SUNDRY NOTICES AND REPORTS ON WELLS
Do not use this form for proposals to drill or to re-enter an abandoned well. Use form 3160-3 (APD) for such proposals.

8. Well Name and No.
AVALON DELAWARE UNIT 546 ✓

9. API Well No.
30-015-24048 ✓

Conditions of Approval

Well: AVALON DELAWARE UNIT-546
API: 3001524048
@ Srfce: T20S-R28E,31.1980s1980e
@ M TD: T20S-R28E,31.1980s1980e
Estate: FIF
CWDW, R of W:
OCD Admn Order, date: SWD-469, 04/08/92
Frmtn, Depths, psig: Wolfcamp, 1800psig

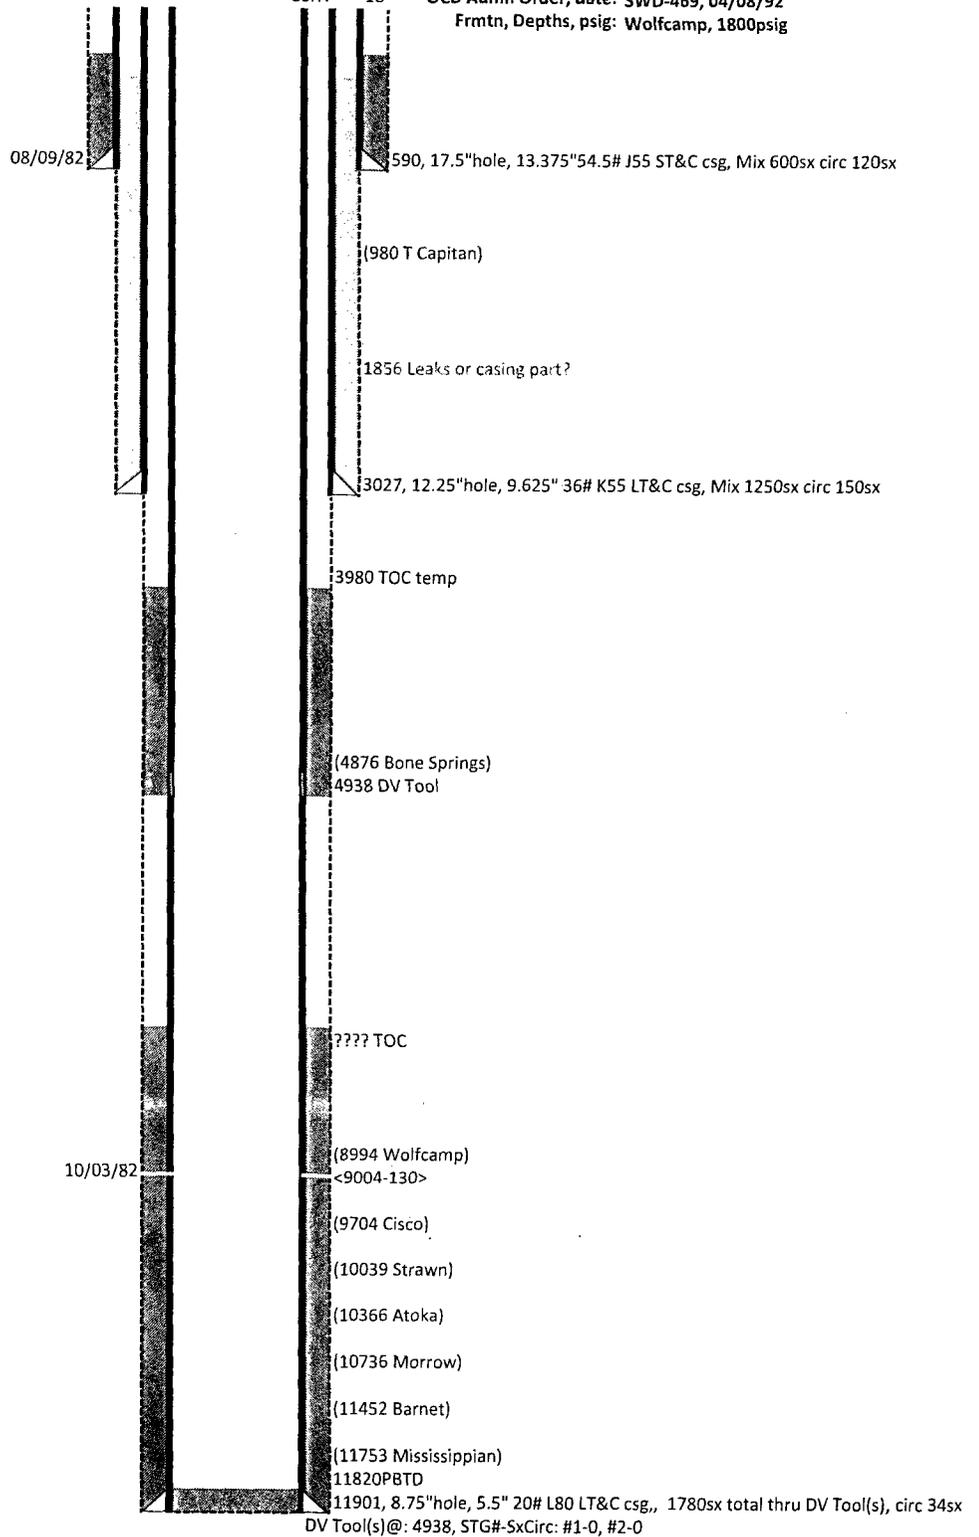
3. **Pull csg from just above 3980, run a belled lead splice just below a DV Tool on new 5 1/2" 17# J55 LT&C csg and circulate cement to surface.**
4. **Approval is for casing replacement only, prior to P&A or installing a liner BLM approval of a notice of intent Form 3160-5 sundry is required.**

5. **Well is located within the Capitan Reef protection area requiring 4 casing strings, with cement covering the production casing 50 feet above the Capitan Reef top.**

6. **Well also is located within the High Cave Karst protection area requiring cement circulated to surface over two casing strings.**
7. Subject to like approval by the New Mexico Oil Conservation Division.
